ECE/TRANS/WP.29/2006/48

World Forum for Harmonization of Vehicle Regulations (WP.29)

PROPOSAL FOR 01 SERIES OF AMENDMENTS TO REGULATION No. 117

(Tyre rolling noise)

Example 1

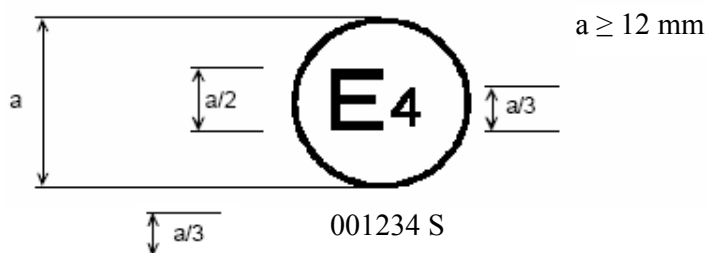
The above approval mark, affixed to a pneumatic tyre shows that a tyre concerned has been approved in the Netherlands (E4) pursuant to Regulation No. 117 (marked by S (rolling sound) only), under approval number 001234. The first two digits of the approval number (00) indicate that the approval was granted according to the requirements of this Regulation in its original form.

Example 2

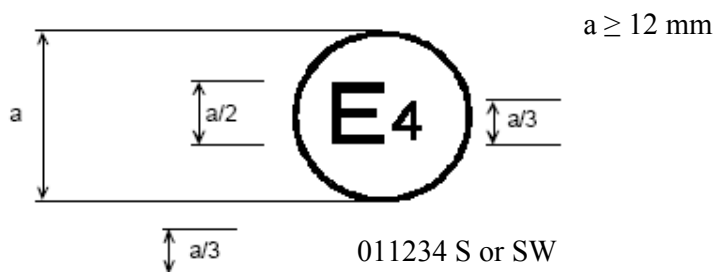
The above approval mark shows that the tyre concerned has been approved in the Netherlands (E4) pursuant to Regulation No. 117 (marked by S (rolling sound) or both S (rolling sound) and W (wet adhesion)), under approval number 011234. This indicates that the approval is for S or both SW. The first two digits of the approval number (01) indicate that the approval was granted according to the 01 series of amendments.

Example 1

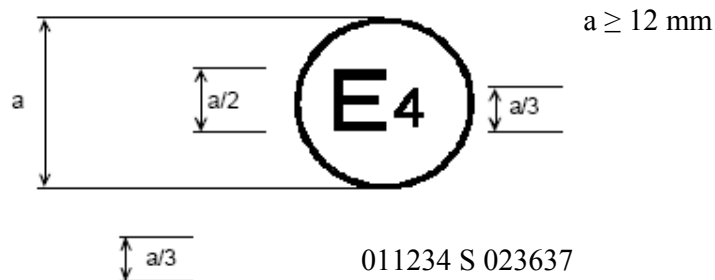
The above approval mark shows that the tyre concerned has been approved in the Netherlands (E4) pursuant to Regulation No. 117 (marked by S (rolling sound)), under approval number 011234 and Regulation No. 30, under approval number 023637. The first two digits of the approval number (01) indicate that the approval was granted according to the 01 series of amendments, but Regulation No. 30 included the 02 series of amendments.

Example 2

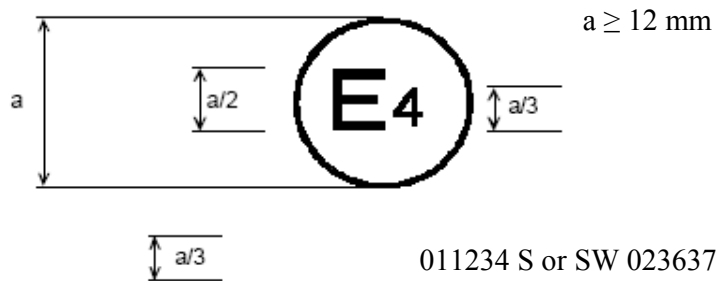
The above approval mark shows that the tyre concerned has been approved in the Netherlands (E4 pursuant to Regulation No. 117 (marked by S (rolling sound) or SW (rolling sound and wet adhesion)), under approval number 011234 and Regulation No. 30 under approval number 023637. The first two digits of the approval number (01) indicate that the approval was granted according to the 01 series of amendments, but Regulation No. 30 included the 02 series of amendments.

Example 3

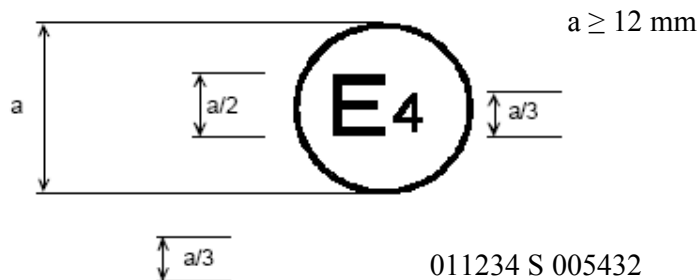
The above approval mark shows that the tyre concerned has been approved in the Netherlands (E4 pursuant to Regulation No. 117 and the 01 series of amendments under approval number 011234 (marked by S only), and Regulation No. 54. This indicates that the approval is for rolling sound (S) only, as Regulation No. 54 approved tyres at present cannot be approved for wet adhesion. The first two digits of the Regulation No. 117 approval number (01) in conjunction with 'S' indicate that the first approval was granted in accordance with Regulation No. 117 which included the 01 series of amendments. The first two digits of Regulation No. 54 (00) indicates that this Regulation was in its original form.

Example 1

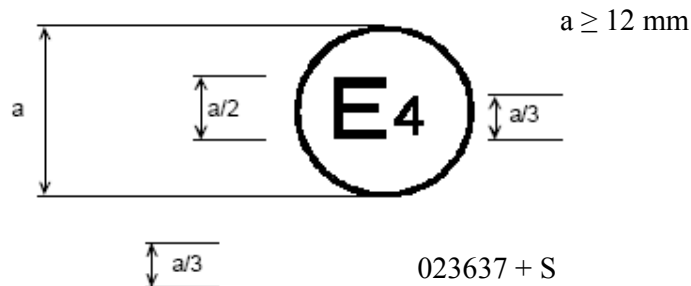
The above approval mark shows that the tyre concerned has been initially approved in the Netherlands (E4) pursuant to Regulation No. 30 and the 02 series of amendments under approval number 023637. It is also marked by + S (rolling sound) which indicates that its approval is extended under Regulation No. 117. The first two digits of the approval number (02) indicate that the approval was granted according to Regulation No. 30 which included the 02 series of amendments. The addition (+) sign indicates that the first approval was granted in accordance with Regulation No. 30 and has been extended to include Regulation No. 117 approval(s).

Example 2

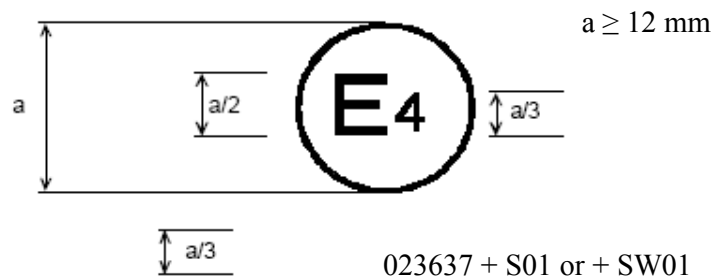
The above approval mark shows that the tyre concerned has been initially approved in the Netherlands (E4) pursuant to Regulation No. 30 and the 02 series of amendments under approval number 023637. This indicates that the approval is for S (rolling sound) or S (rolling sound) and W (wet adhesion). The S or SW followed by (01) indicates that it has had its approval extended under Regulation No. 117 which included the 01 series of amendments. The first two digits of the approval number (02) indicate that the approval was granted according to Regulation No. 30 which included the 02 series of amendments. The addition (+) sign indicates that the first approval was granted in accordance with Regulation No. 30 and has been extended to include Regulation No. 117 approval(s)."
